DOCKET 50-155 - LICENSE DPR-6 -
BIG ROCK POINT PLANT - RESPONSE TO NRC
STAFF CONCERNS - AMENDMENT 2 TO SPENT FUEL
RACK ADDITION - "CONSOLIDATED APPLICATION"

DOCKET 50-155 - LICENSE DPR-6 -
BIG ROCK POINT PLANT - RESPONSE
TO STAFF QUESTIONS ON MCPR TECHNICAL
SPECIFICATION CHANGE REQUEST

RETRAN ANALYSIS
SENSITIVITY

DESCRIPTION OF COBRA ANALYSIS MAJOR ASSUMPTIONS

BRP SYSTEM NODALIZATION DIAGRAM

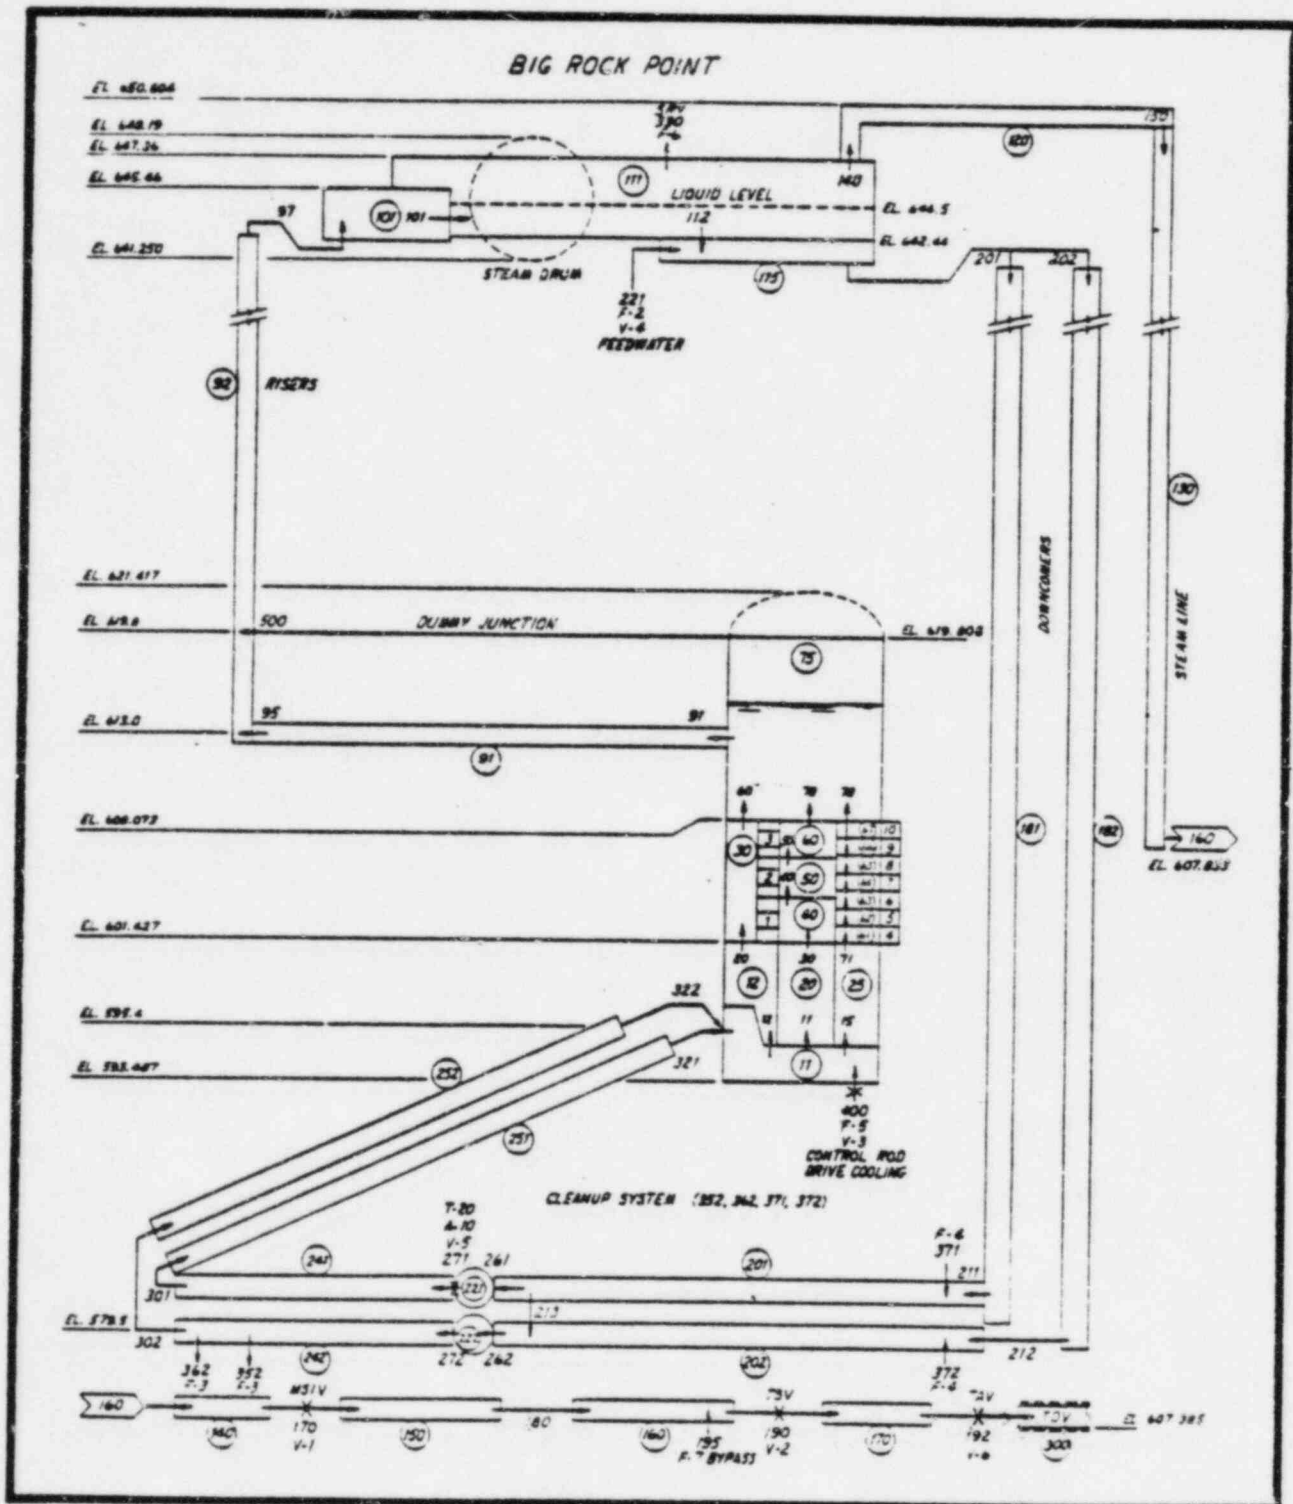
Question

Show that the RETRAN analysis is conservative by evaluating the sensitivity of the model (in terms of $\Delta\text{MCPR}/\text{initial MCPR}$) to the following parameters:

Void Coefficient
Doppler Coefficient
Scram Reactivity
Prompt Neutron Heating
Void Fraction Model (Homogeneous Assumption)
Fuel Heat Transfer Model
System Inertia (L/A)
Core Pressure Drop (or Core Bypass Flow)
Separator Inertia (L/A)
Separator ΔP
Steamline Pressure Loss (Loss Coefficient)

Evaluate to include Sensitivity Study or if sensitivity is known, provide a written basis why the analysis assumed a conservative value of the parameter.

- 1) Steam Line Pressure Loss - The steam line loss coefficients in junctions 140, 150, 160, 170 and 180 (see attachment 1) were increased 50% and decreased 50% from the base case. The results below show that MCPR is insensitive to changes in steam line pressure losses.

Base Case	0.5 x Base Case Coefficients	1.5 x Base Case Coefficients
Initial CPR	1.591	1.591	1.591
MCPR	1.320	1.321	1.320
MCPR change from base case	N/A	+0.001	0.0
MCPR-MCPR _(Base) x 100%	N/A	+0.08%	0.0%
MCPR _(Base)
